**TYPE III – PLANNING COMMISSION
STAFF REPORT AND RECOMMENDATION
November 16, 2018**

FILE NUMBER: GLUA-18-00025
VAR-18-00001
SP-18-00106
MD-18-00001 (of CU 14-01)

REQUEST: Minor Site Plan and Design Review, Modification to Conditional Use CU 14-01,
Minor Variance for a 7-Bed Expansion to a 31-Bed Assisted Living Memory Care
Facility at the NW corner of Amanda Court and South End Road

LOCATION: 950 South End Road, Oregon City, OR 97045
Clackamas County Map 3-1E-01AD, Tax Lot 3100

Figure 2: Proposed Site Plan – Not to Scale

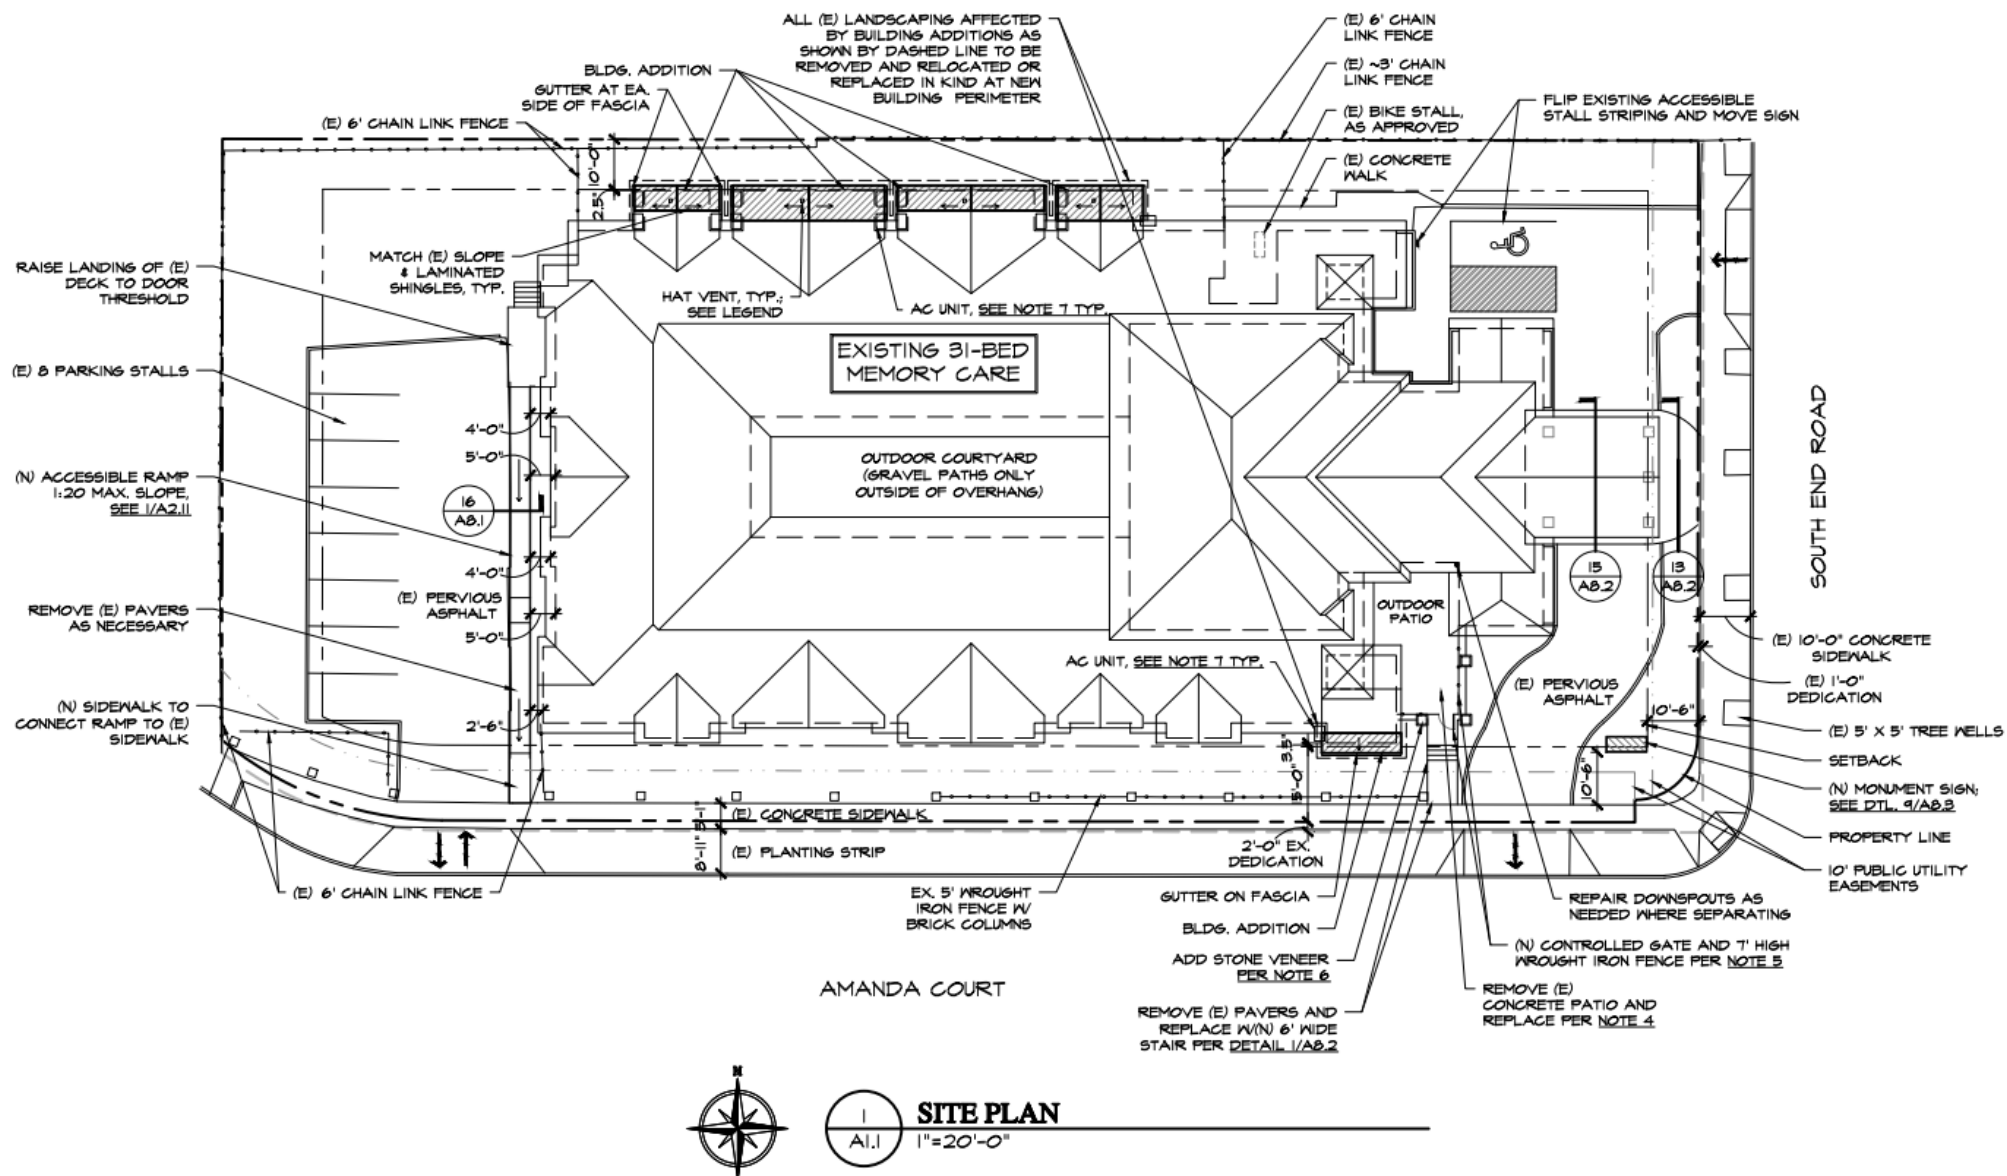
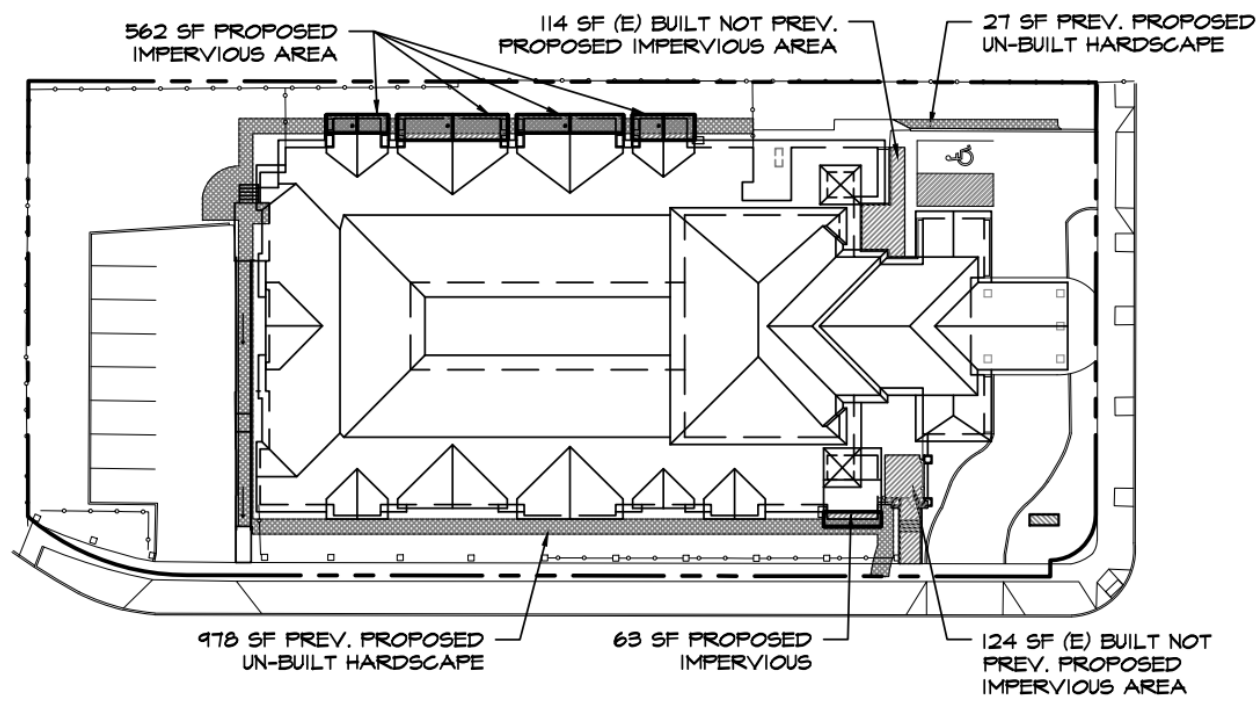
The proposed hardscape pathways on the south and north sides of the building appear to be less than five feet wide. Pathways are not required around the entire building in order to comply with this section due to the sidewalk connection, however, since they are proposed, they are required to be at least five feet in width. Therefore, prior to issuance of a building permit, the applicant shall either remove the on-site paths which are not required that are less than five feet in width on plan submittals or revise the plans to indicate 5' wide paths and widen the required pathways to 5 feet. Because the building fronts on the street, the existing sidewalk may be used to meet this standard. **Staff has determined it is possible, likely and reasonable the applicant can meet this standard by complying with the recommended conditions of approval.**

Finding: Complies with conditions. The submitted site plans indicate chain link fencing at the northwest and southwest corners of the building. No other prohibited materials are identified within the submittal. The applicant shall remove the chain link fencing and or replace it with non-prohibited materials prior to issuance of a building permit. **Staff has determined it is possible, likely and reasonable the applicant can meet this standard by complying with the recommended conditions of approval.**

1. Width of on-site pathways. Prior to issuance of a building permit, the applicant shall either remove the on-site paths that are less than five feet in width on plan submittals, or revise the plans to indicate 5' wide paths in accordance with OCMC 17.62.050.A.9. For buildings fronting on the street, the public sidewalk may be used to meet this standard. (P)

2. Chain link fence. Prior to issuance of a building permit, the applicant shall remove any chain link fencing and / or replace it with non-prohibited materials in accordance with OCMC 17.62.050.A.21 and OCMC 17.54.100. (P)

Figure 6: Proposed Modifications to South Elevation – Facing Amanda Court – (Not to Scale)

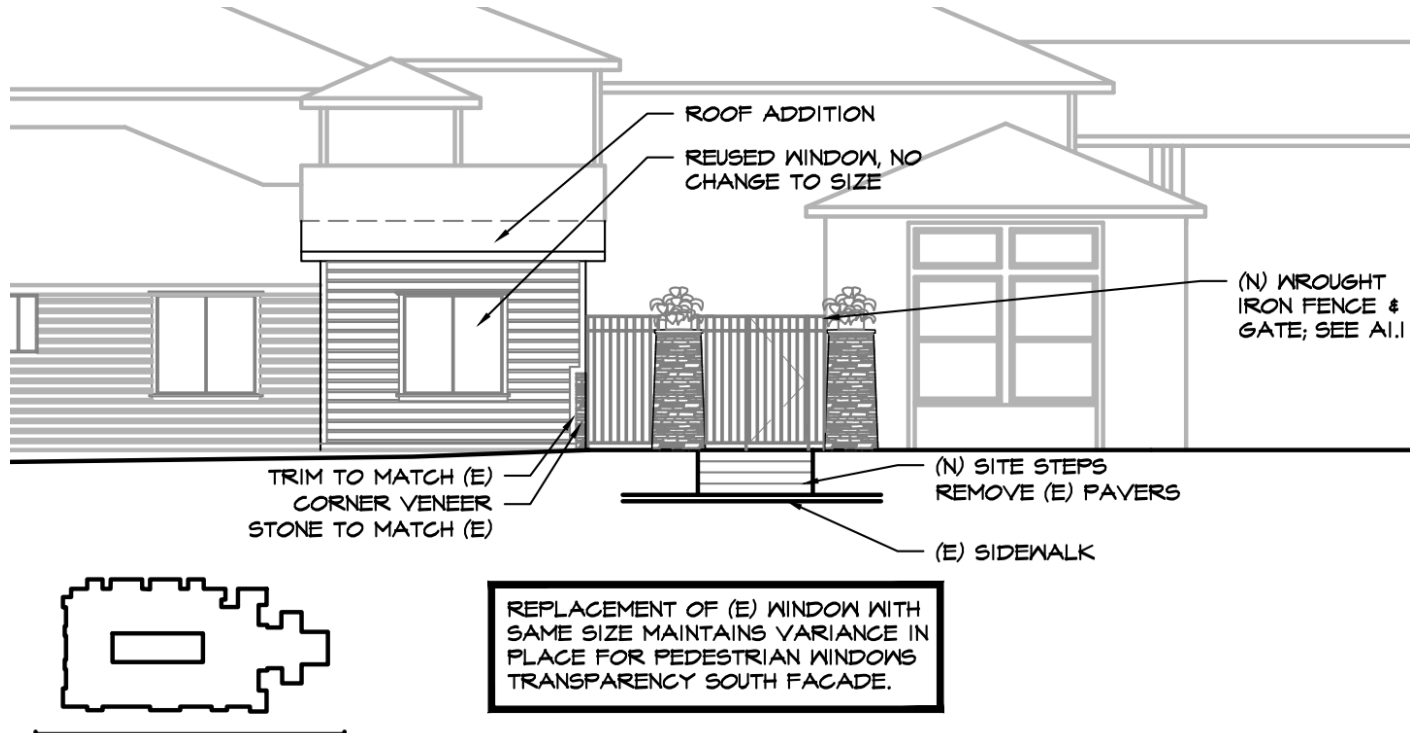
An email comment from Gregory Peterson regarding the screening requirements for ground mounted mechanical equipment. Mr. Peterson stated that several air-conditioning units on the south exterior are not properly shielded from view, as required by OCMC 17.62.050.A.20.C.

comment was received regarding the screening requirements for ground mounted mechanical equipment. According to the comment, several air-conditioning units on the south exterior are not properly shielded from view. Prior to issuance of a building permit, the applicant shall provide ornamental fences, screening enclosures, trees, or shrubs that block at least eighty percent of the view of the mechanical units from the street. **Staff has determined it is possible, likely and reasonable the applicant can meet this standard by complying with the recommended conditions of approval.**

5. Screening for mechanical equipment. Prior to issuance of a building permit, the applicant shall provide ornamental fences, screening enclosures, trees, or shrubs that block at least eighty percent of the view of the mechanical units from the street in accordance with OCMC 17.62.050.A.20. (P)
